Product:	XETK-V1.0	Rev :	09	Page 1 of 13
Title :	Change Information

Product :	XETK-V1.0			
Title :	Change Information			
File :	XETK-V1.0_Change_Information_V09.doc			
TTNR :	XETK-V1.0A	F-00K-105-755		
	XETK-V1.0B	F-00K-105-756		
Comments :	Current shipped (hardware state):		D012	
	Current released firmware version:		HSP 8.0.3	
Created:	Name R. Mai	Department PHW/EES1	Signature R. Mai	Date 2009-11-16
Released:	Name G. Maier	Department PHW/EES23	Signature G. Maier	Date 2009-11-17

4.2 Product variants

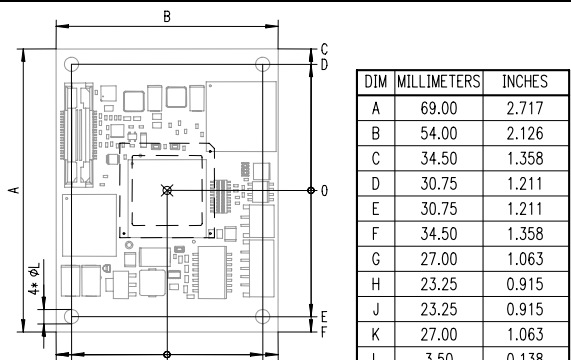
In general the XETK-V1.0 can be purchased in two variants. The electrical and system functionality is identical. Only the dimensions are different.
